RE: <u>Arlington Mixed-Use Project – Response to Caltrans Comment on City's Intent to Override</u>

Technical Memorandum

Subject: Arlington Mixed-Use Project – Response to Caltrans Comments on City's Intent to Overrule

Figure 1 – RAL Airport Noise Abatement Procedure Map

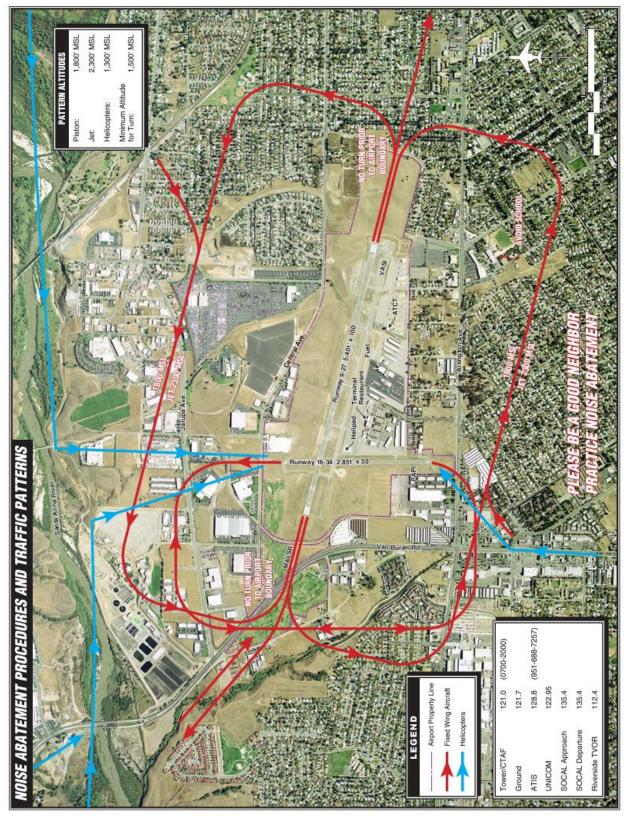
- There are substantial open land areas north and west of the Airport that meet the open land requirement.
- The actual aircraft accident and incident information specific to the Airport and the Project site do not support the generalized assertion by the ALUC that not meeting their open land requirements increases the risk of harm to the general public and Project residents. In fact, the overall safety record of aircraft operations on and around the Airport and the improving national trends in general aviation safety over the last 20 years argue toward one of the safest activities in the community¹³. The Foulger Pratt Study and Findings provides an analysis of the actual aviation safety and risk level associated with aircraft overflights of the community around the Airport (Foulger Pratt, pp. 6-8).
